March 5, 2009

Subject: UniStar Nuclear Energy, NRC Docket No. 52-016  
Calvert Cliffs Nuclear Power Plant, Unit 3  
Environmental RAIs No. 1001 through 1011

The purpose of this letter is to respond to the requests for additional information (RAIs) identified in the NRC letter to UniStar dated February 3, 2009 (Reference 1). The RAIs address figures needed to publish the environmental impact statement (EIS) and information necessary for completion of regulatory reviews.

**ESRP 4.3.1 - 4**

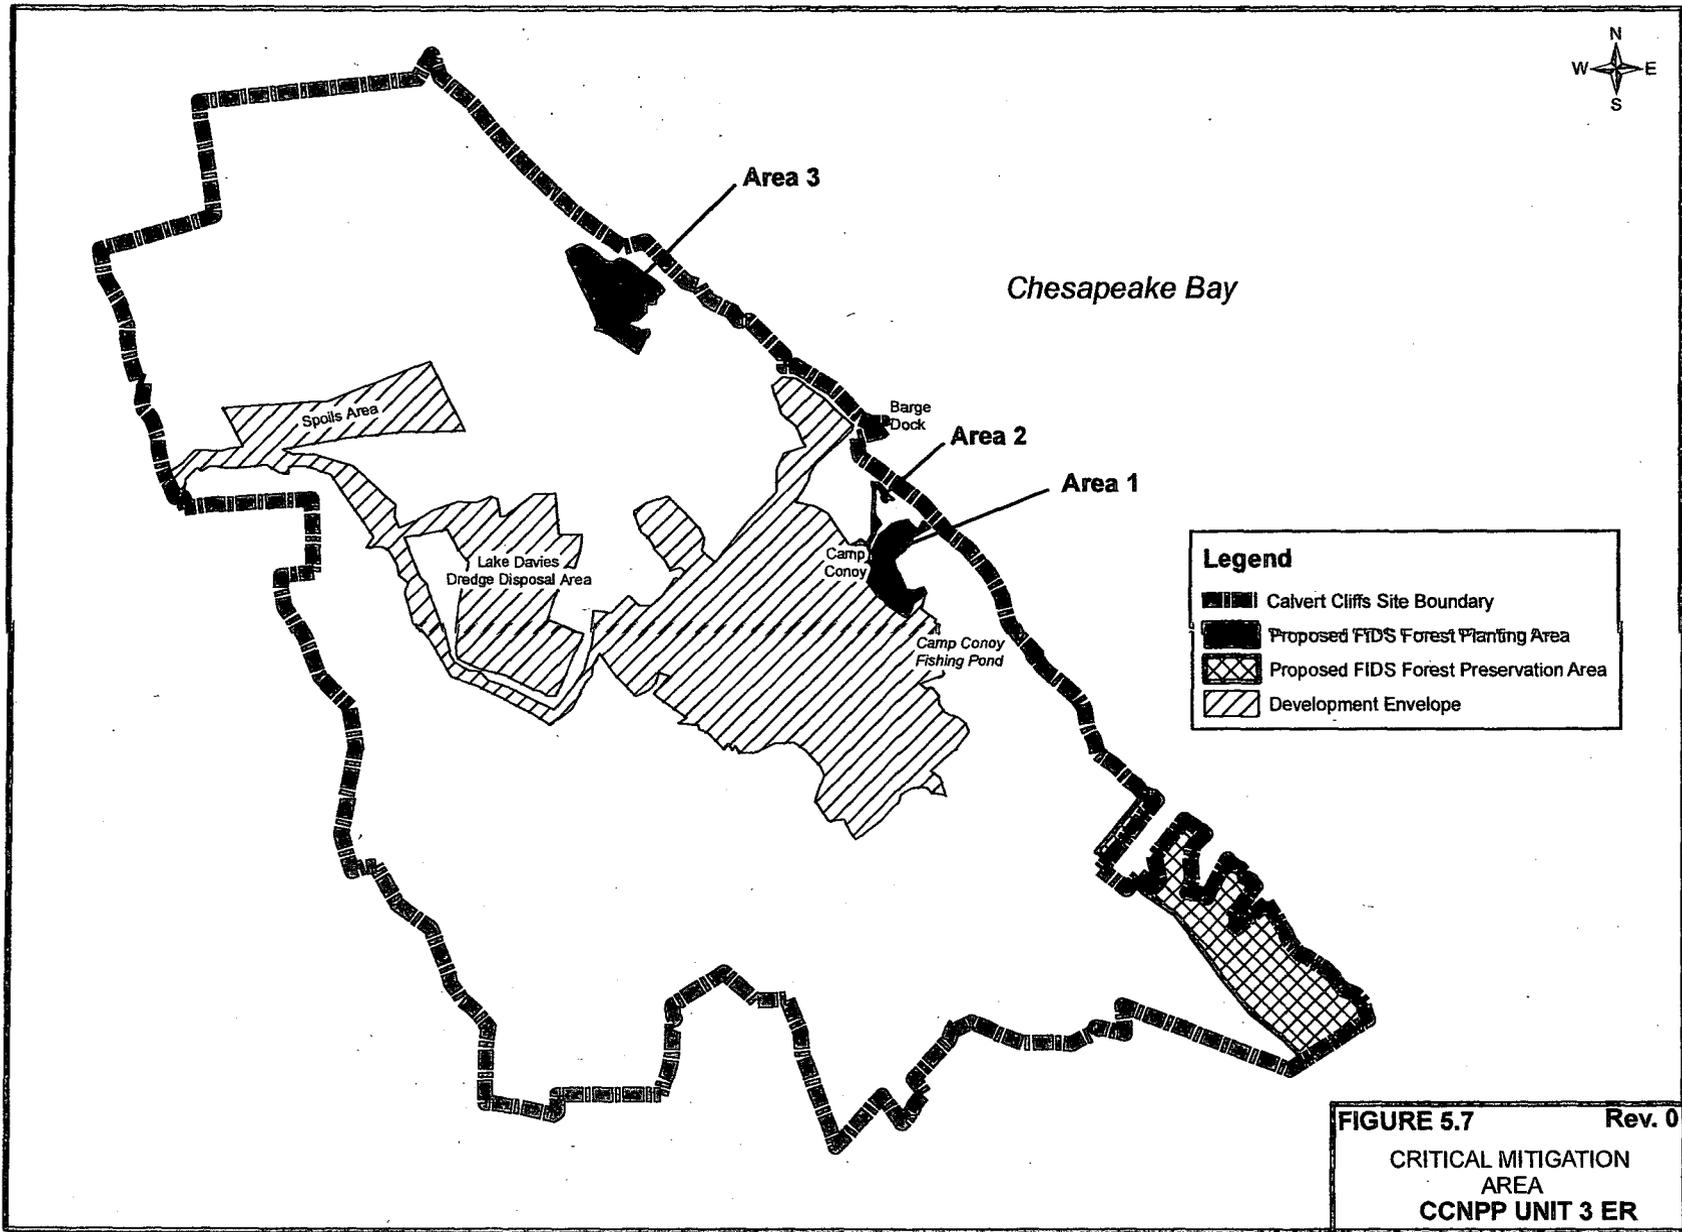
Provide a legible graphic of Fig 5-7 from CPCN Final Report 16 July 2008, with a legible legend depicting only the following attributes: Calvert Cliffs site boundary, Chesapeake Bay label, Development Envelope, proposed FIDS Forest Planting Area, Proposed FIDS Forest Preservation Area.

UniStar has prepared a figure for use in the printed version of the EIS. See attached figure.

**ESRP 4.3.2 - 2**

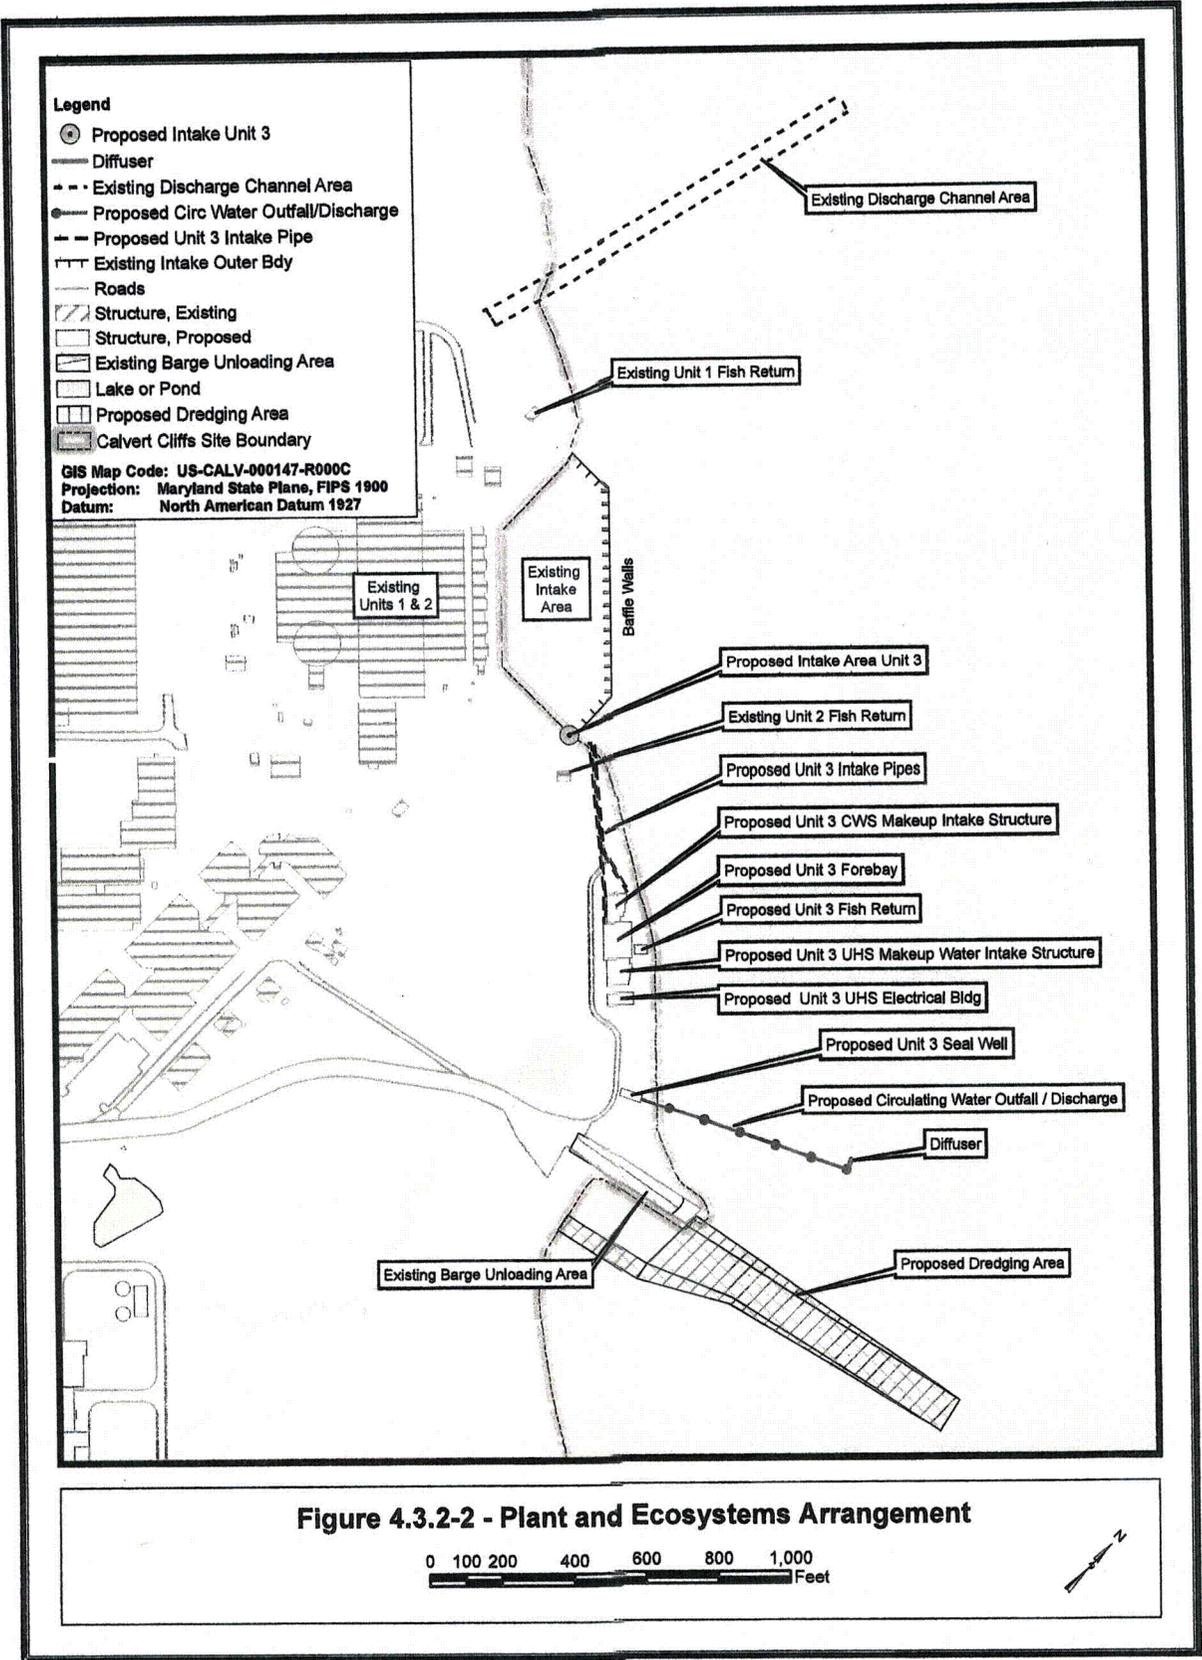
Provide new graphic with a legible legend depicting the locations of the intake system, fish return system, and discharge area for Units 1 and 2, the intake system, fish return system, and discharge pipe for proposed Unit 3, the barge dock area and the area to be dredged. The scale should be such that it includes the complete area from north of the current intake area (including any plant-related discharges north of the intake) to south of the barge dock facility.

UniStar has prepared a figure for use in the printed version of the EIS. See attached figure.

**Figure 3 Annotated**  
**SITE PLAN @ UNIT 3 INTAKE**  
**STRUCTURE - SHT 1**

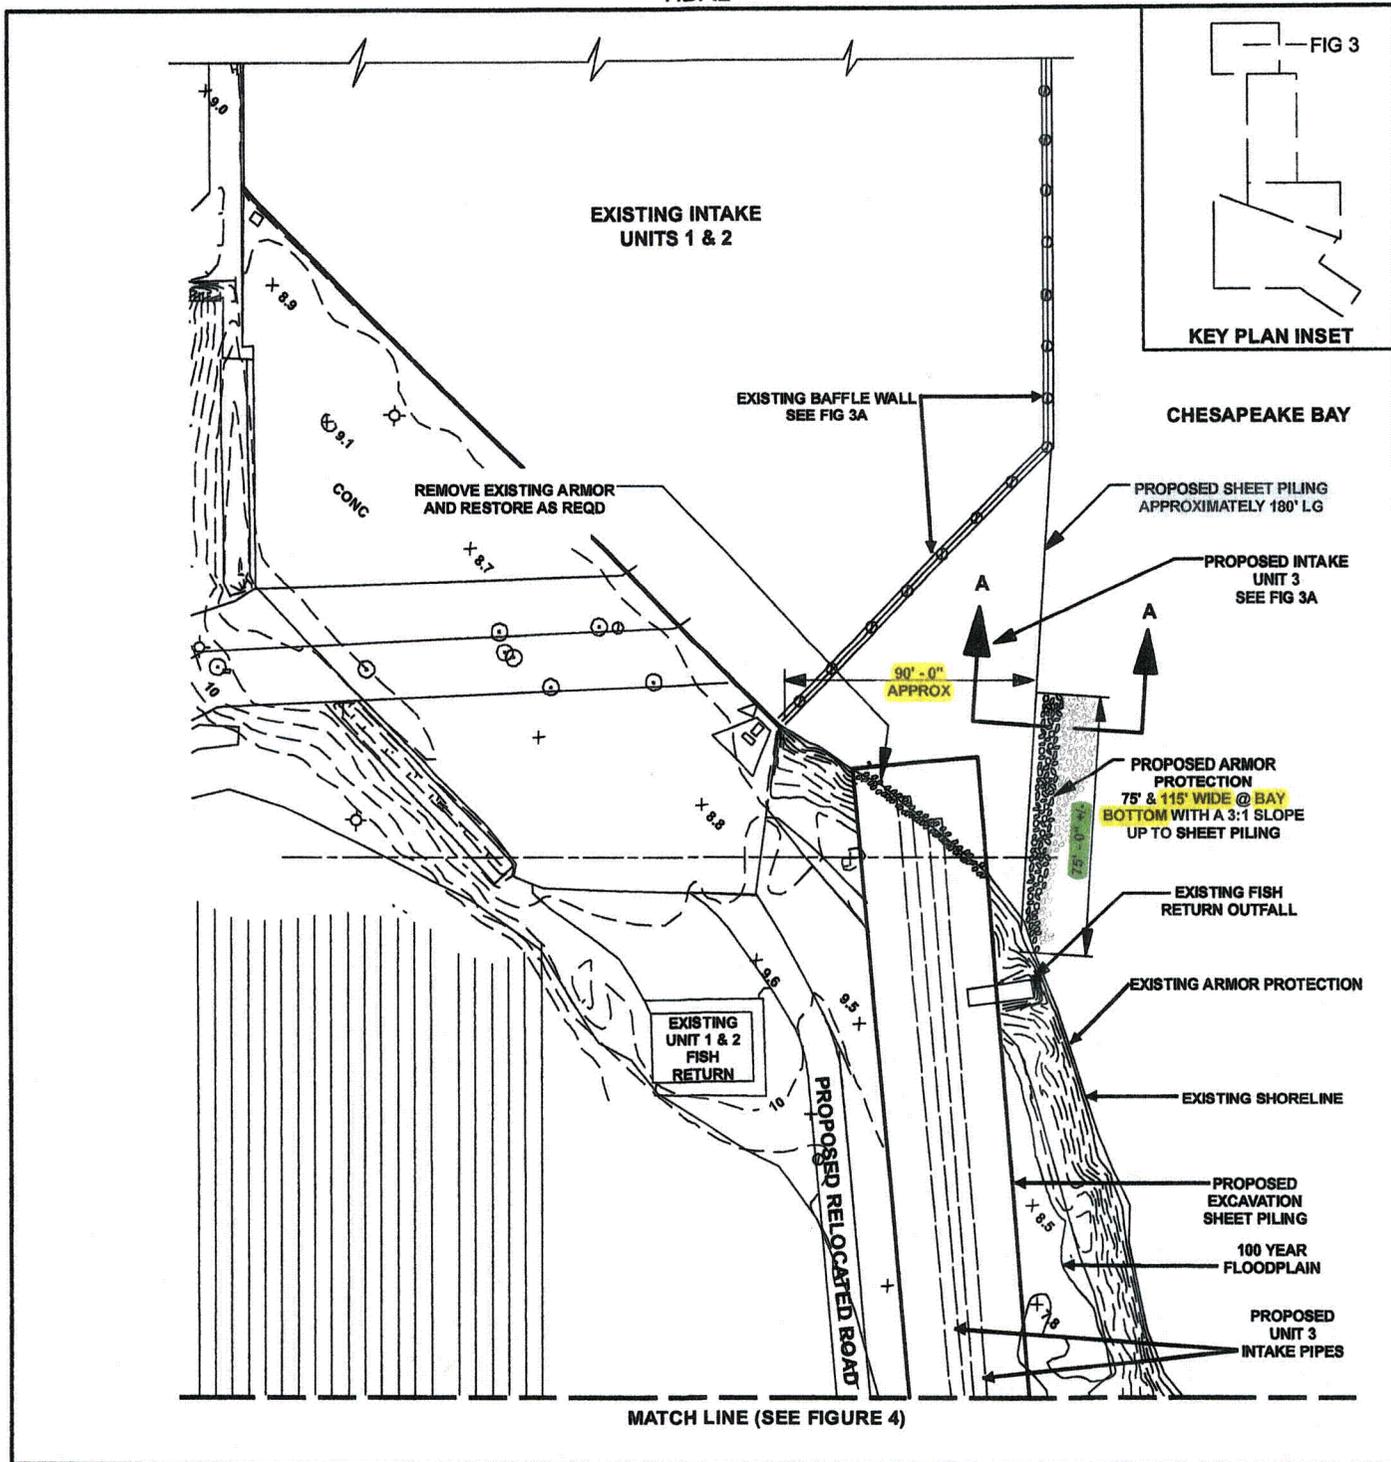
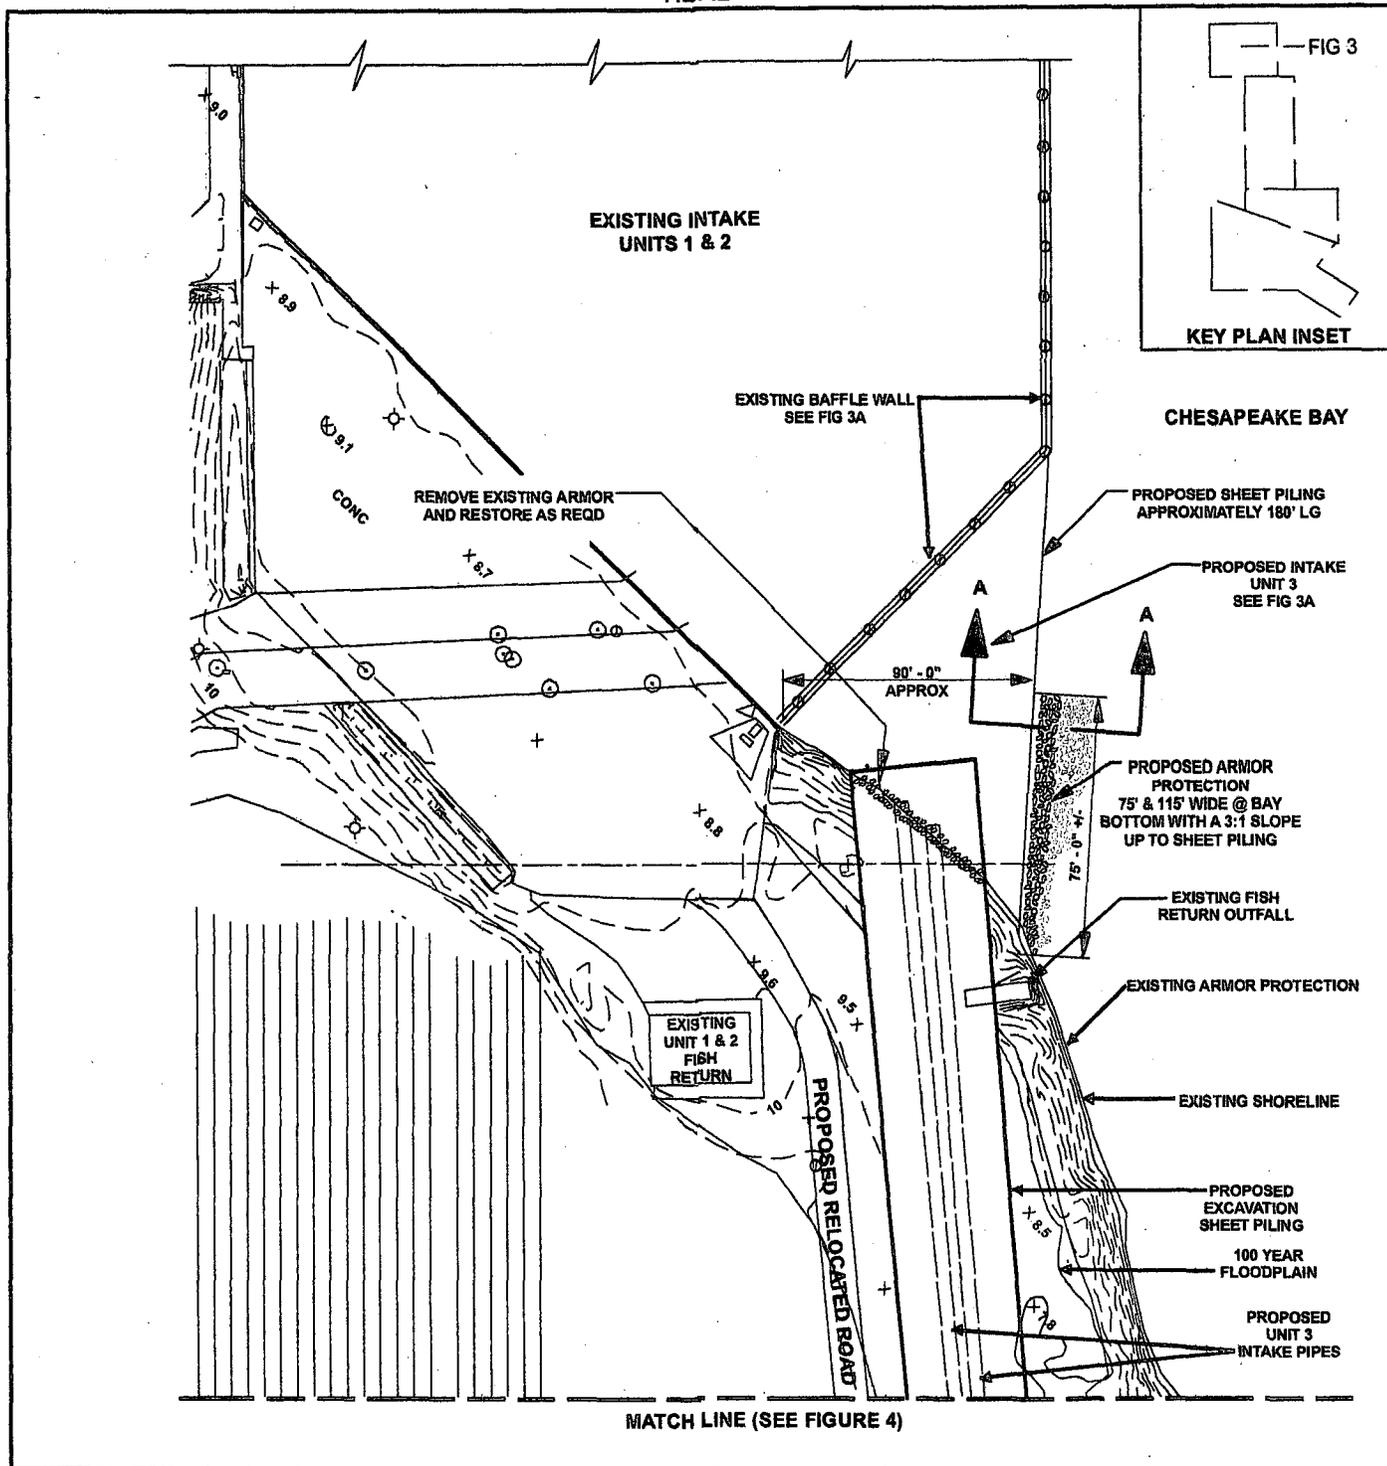
The September 29, 2008 RAI response to RAI #6 includes a Fig. 3A, which refers (within the figure) to Fig. 3B (Proposed Armor Protection—see Figure 3B for Extent of Protection), which was not found. Provide this or a new graphic that shows the bayward extent of the armoring that would be added to protect the new baffle wall installed for the intake system for proposed Unit 3.

Figure 3, "Site Plan @ Unit 3 Intake Structure - Sht 1", is the figure that shows the bayward extent of the armoring as 75'-0" +/- . This figure references Figure 3A, "Site Plan @ Unit 3 Intake Structure - Sht 2", which provides a more detailed view of the wedged-shaped pool intake structure proposed for Unit 3. This figure, in turn, references Figure 3B, "Proposed Armor Protection".

Figure 3 Sht 1 will be updated to reduce 115' to 95' and Fig 3B will be incorporated into a future revision of the COLA. Annotated figures are for information only.
